b. DEVELOPMENT			Rev.			2002 APR 17 P. 17		
c. PRODUCT			SCN			Revised		
13. TITLE OF CHANGE CHANGE VARIOUS VENDOR NAMES AND HARDWARE CALLOUTS			15. PROCURING CONTRACTING OFFICER			AMSTA-AR-OAD

14. CONTRACT NO. AND LINE ITEM			a. NAME (First, Middle Initial, Last)			2002 APR 17 P. 17		
			b. CODE			c. TELEPHONE NO.		
16. CONFIGURATION ITEM NOMENCLATURE HOWITZER, TOWED, M198 - HIPE PROGRAM						17. IN PRODUCTION		
						NA YES NA NO

18. ALL LOWER LEVEL ITEMS AFFECTED								
a. NOMENCLATURE POWER SUPPLY DISTRIBUTION UNIT ( PSDU )				b. PART NO. 12993100			c. NSN	
19. DESCRIPTION OF CHANGE CHANGE / CORRECT VENDOR NAMES AND HARDWARE PART NOS. SOME DRAWINGS WERE CHANGED FROM SOURCE CONTROL DRAWINGS TO VENDOR ITEM DRAWINGS.

<b>DATE:</b> 20020410	<b>ECP NUMBER:</b> L2A2009	<b>NOR SHEET NUMBER:</b> 2 of 2	<b>NOR NUMBER:</b> 17
<b>CAGE CODE:</b> 19200	<b>DOCUMENT NUMBER:</b> 12993189	<b>DOCUMENT TITLE:</b> SOCKET

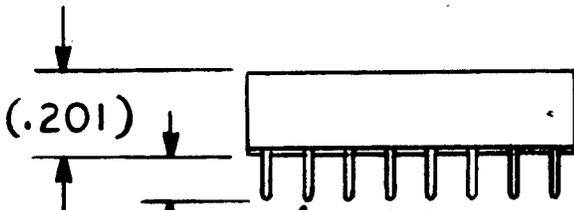
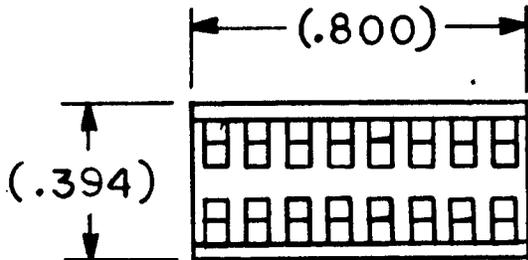
CHANGE VIEW PICTORIALY AND ADD DIMENSIONS:

FROM:

TO:

(.118)      (.100)

(.189)      (.300)

(16X Ø.039)  
REQ'D MOUNTING HOLE
